SPARC Enterprise™ M8000/M9000 Servers Product Notes

For XCP Version 1093

FIGURE 3-9 Three-Phase Star Power Supply Connections

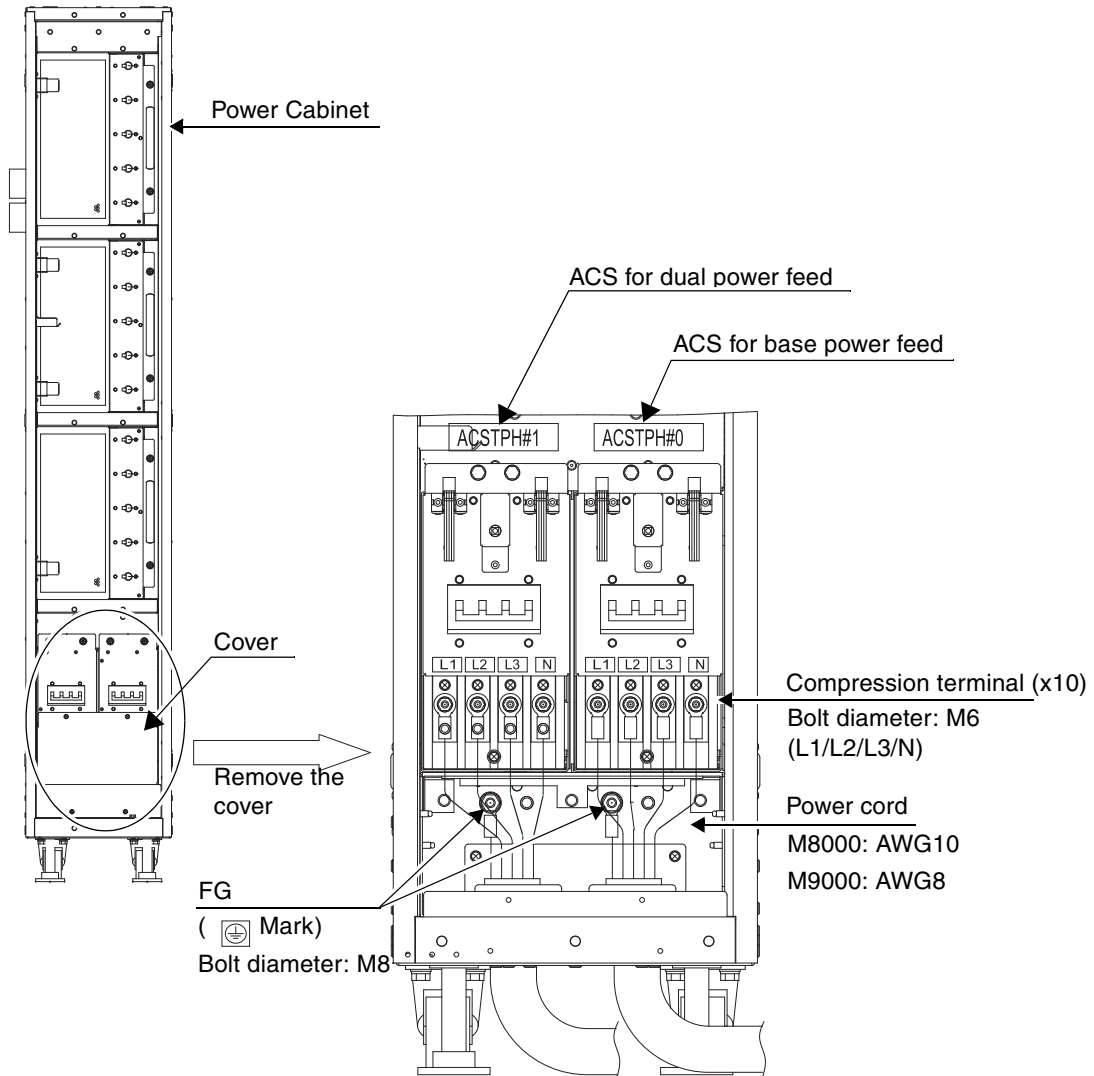
3-22	FIGURE 3-9, "Three-Phase Star Power Supply Connections" in Section 3.3.3 will be changed. See “Power Cord Connection Specifications” on page 21 for detail.
	3-24	Circuit breaker capacity of customer panel board (Europe) for 3 phase-star power supplies in Table 3-9 will be corrected. The value for SPARC Enterprise M8000 server should be 32A, not 30A.
